Amendment No. 4 (12/2023)
To
AIS-156-2020: Specific Requirements for L Category Electric Power Train
Vehicles

Amendment 3 to AIS-156 (09/2022)

Amendment 2 to AIS-156 (08/2022)

Specific Requirements for L Category Electric Power Train Vehicles

Figure 1

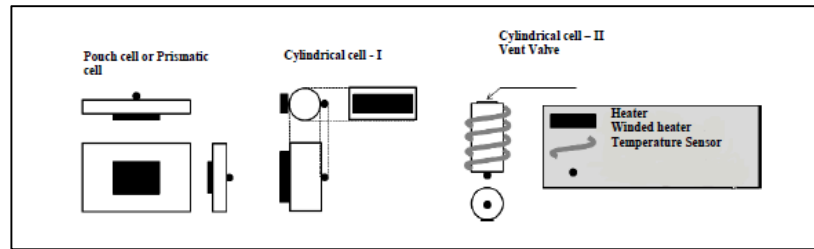
Substitute existing Annex 8J and Annex 8K with following text:

Note: As for the set-up using a heater, place a temperature sensor on the far side of heat conduction, for example, an opposite side of the position where heater is placed (see Figure 1). If it is difficult to apply the temperature sensor directly, place it at the location where the continuous temperature rise of initiation cell can be detected.

Figure 1

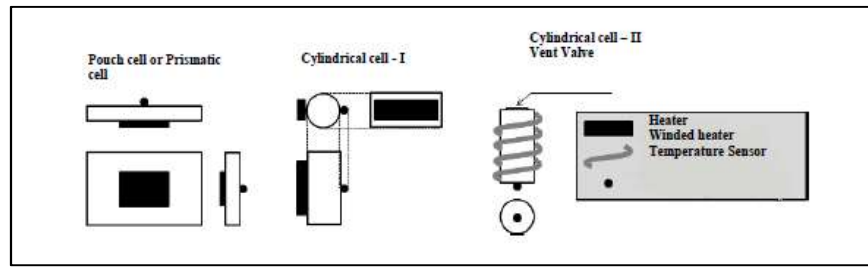
Add new Annex 8J and 8K after Annex 8I

Note: As for the set-up using a heater, place a temperature sensor on the far side of heat conduction, for example, an opposite side of the position where heater is placed (see Figure 1). If it is difficult to apply the temperature sensor directly, place it at the location where the continuous temperature rise of initiation cell can be detected.
